**RE: Response to Comments
Milne Port Stockpile Water Management Upgrades - Modification Request No. 9
Mary River Project, Type 'A' Water Licence - 2AM-MRY1325 - Amend. No. 1**

Table 1-1: Baffinland Response to QIA and CIRNAC Comments RE: Modification Request No. 9

Port Site – Stockyard 2 – Northern Access Roads Plan and Profile

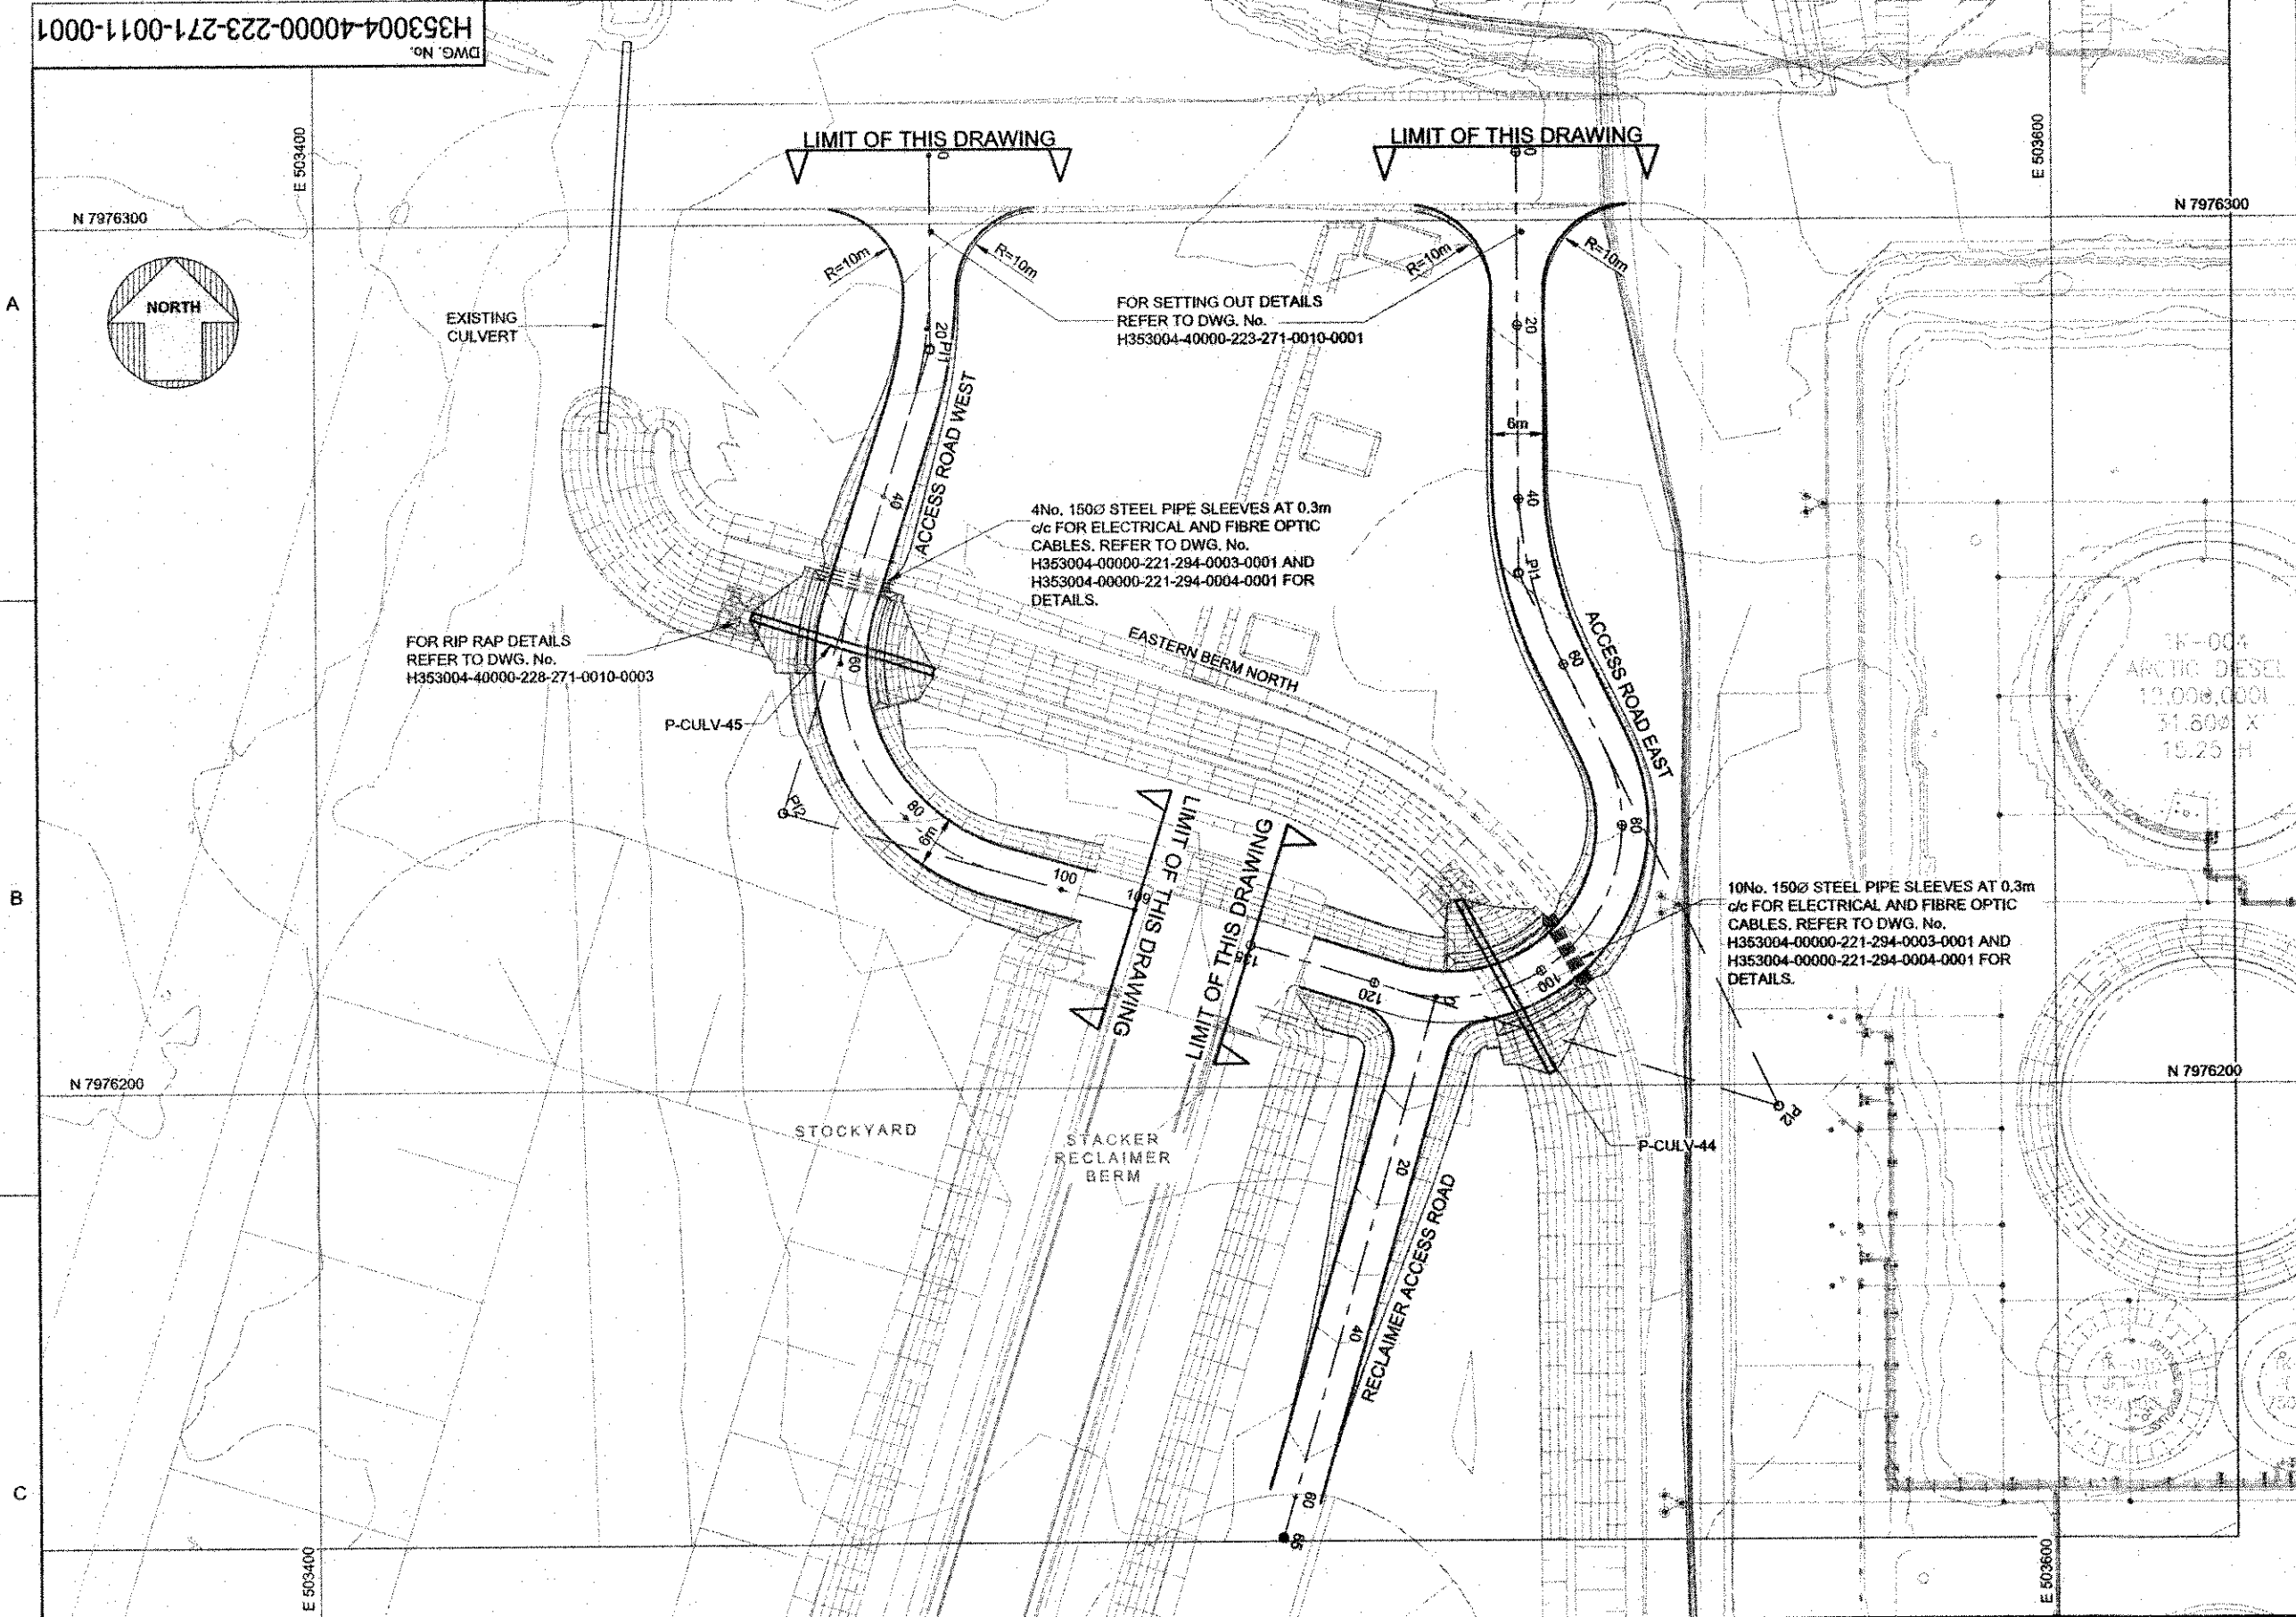
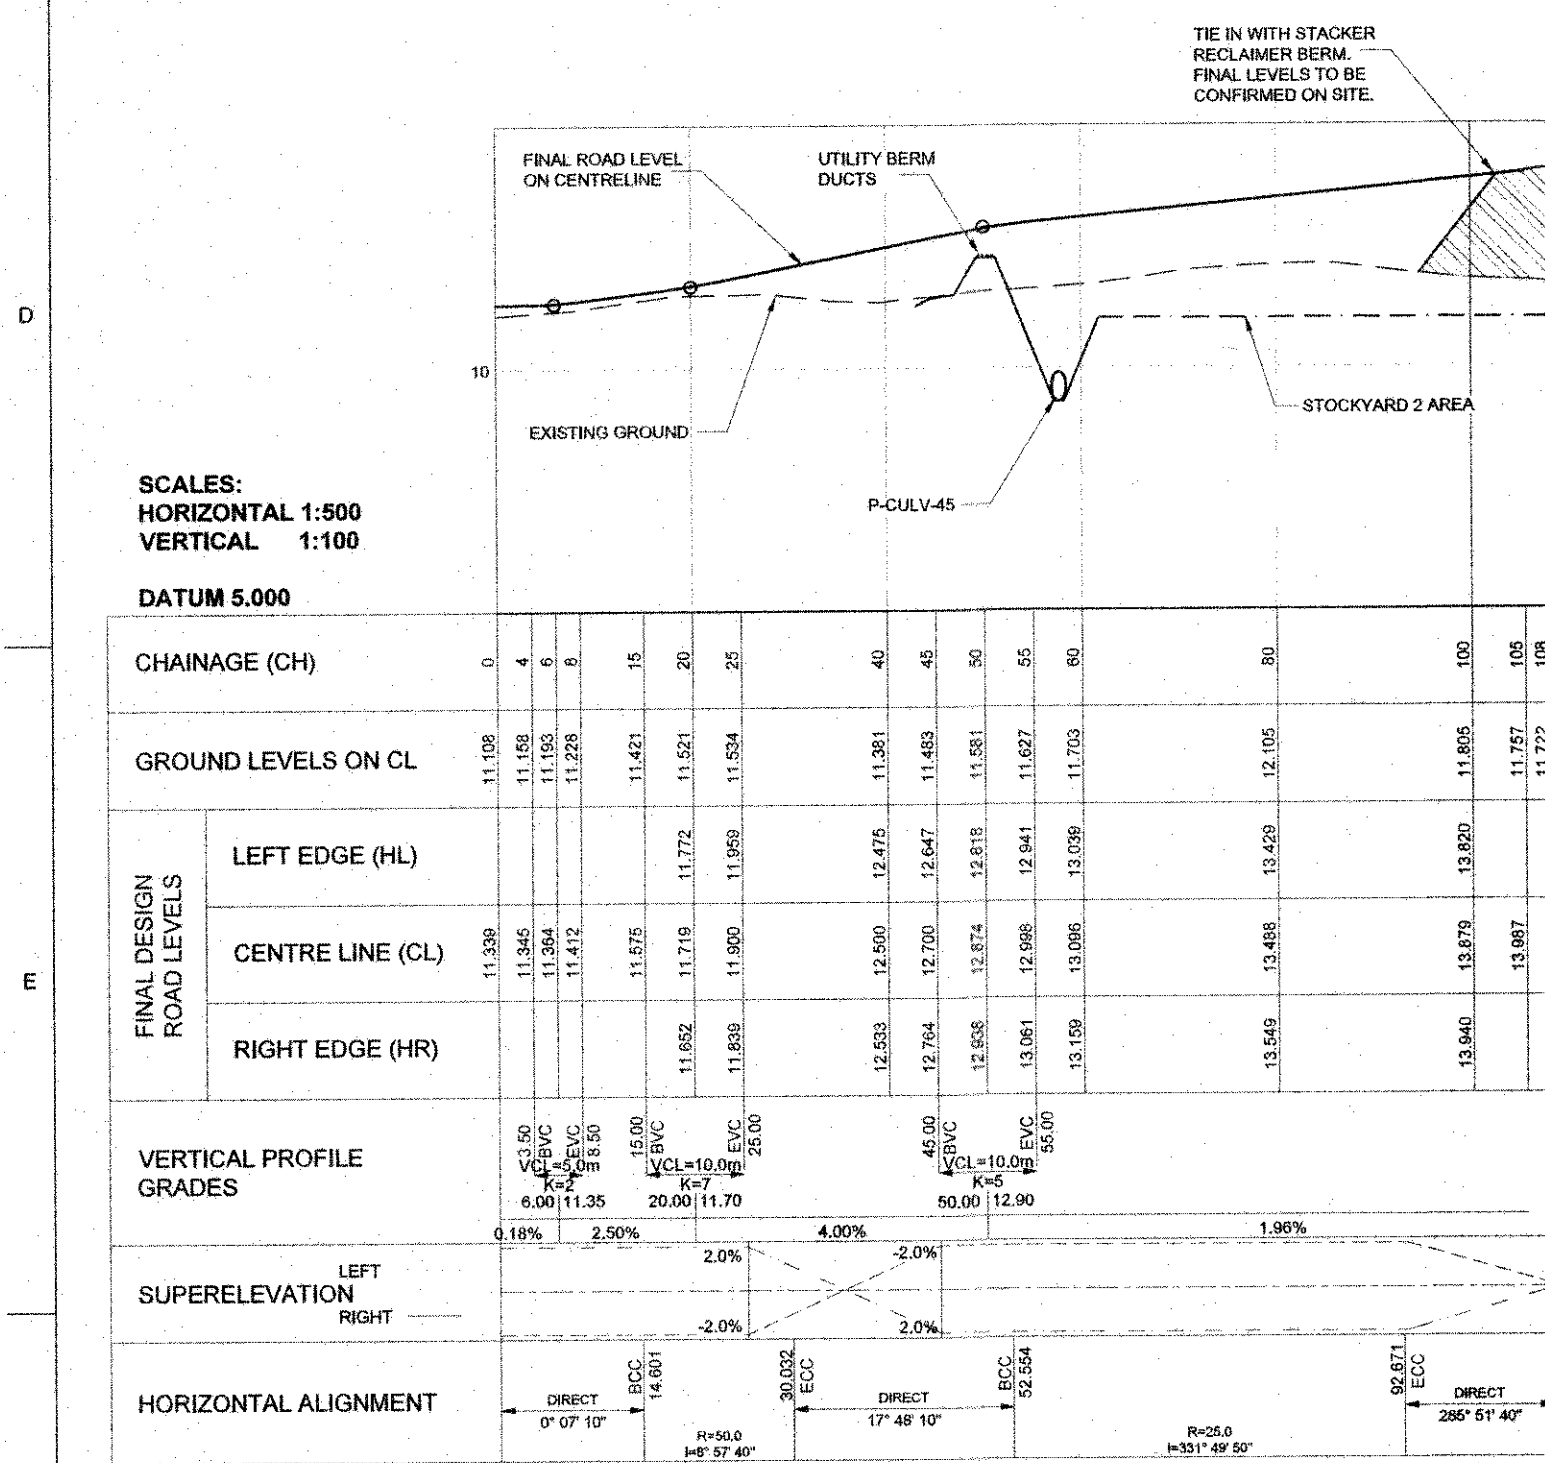
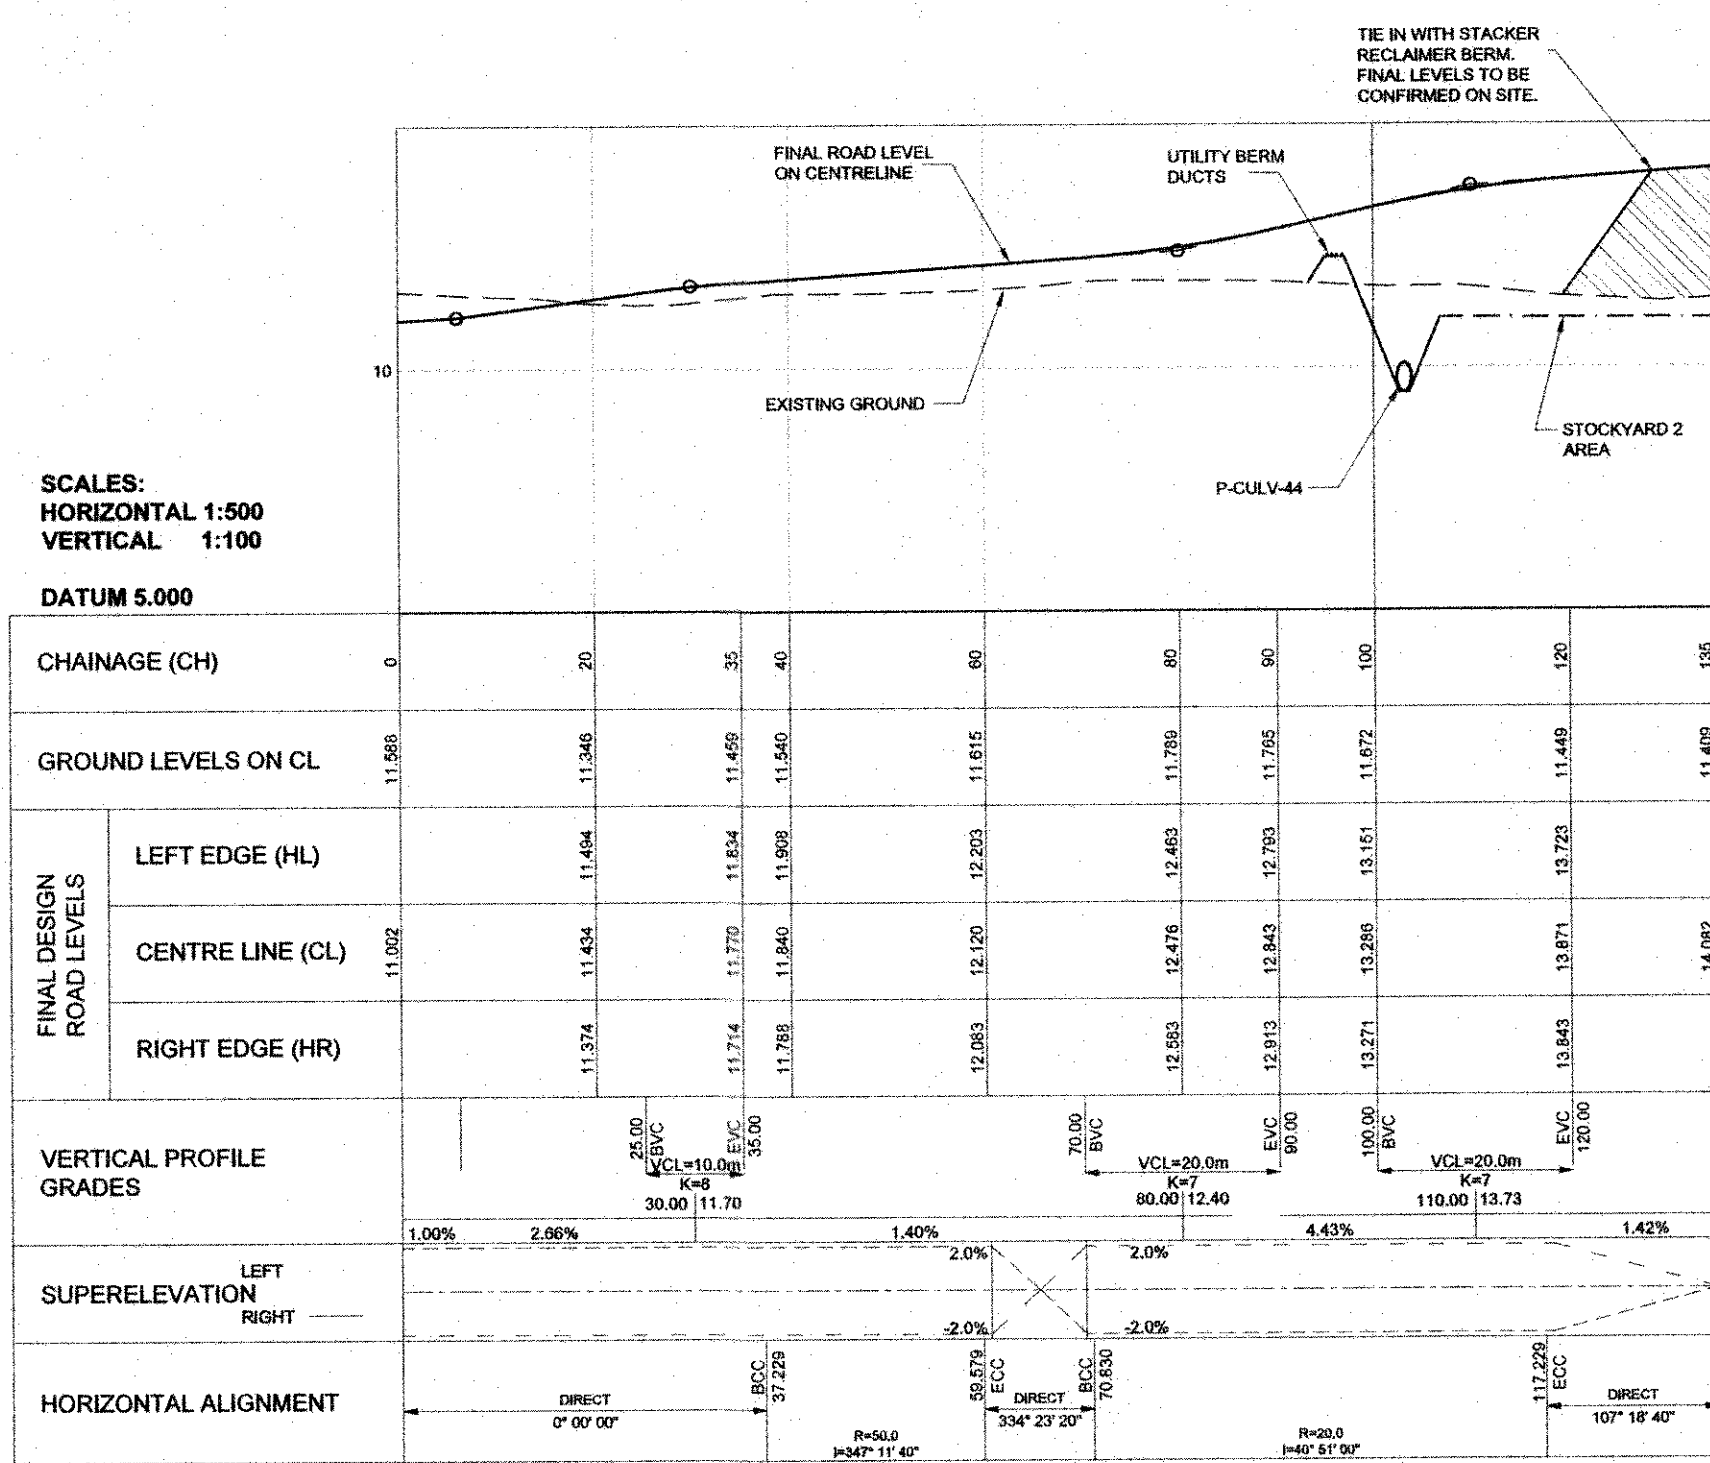
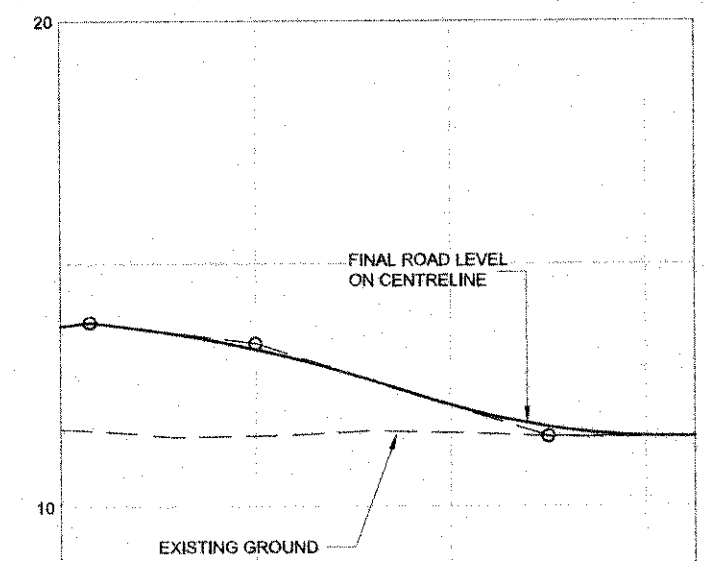
3	Baffinland to provide detailed for construction drawings for the two new culvert crossings installed beneath access roads in addition to the existing culvert.	Construction details for the two new culverts are outlined in the Issued-for-Construction Drawing: Port Site - Stockyard 2 Northern Access Roads Plan and Profile (H353004-40000-223-271-0011-0001, Rev. 0), developed by Hatch and provided as Attachment 2 of this submission.
4	Baffinland to provide the borehole log and precise location with respect to proposed facilities for Borehole BH 16-M001.	The borehole report for BH16-M001 is provided as Attachment 3 of this submission. UTM coordinates are provided in the borehole report.
5	Baffinland to provide the quantities and the physical characteristics of construction materials.	Section 6.2 of the Hatch design brief indicates the types of materials to be used. Quantities of construction material is not relevant to the constructability of the structure or are a required detail for a Water Licence Modification.
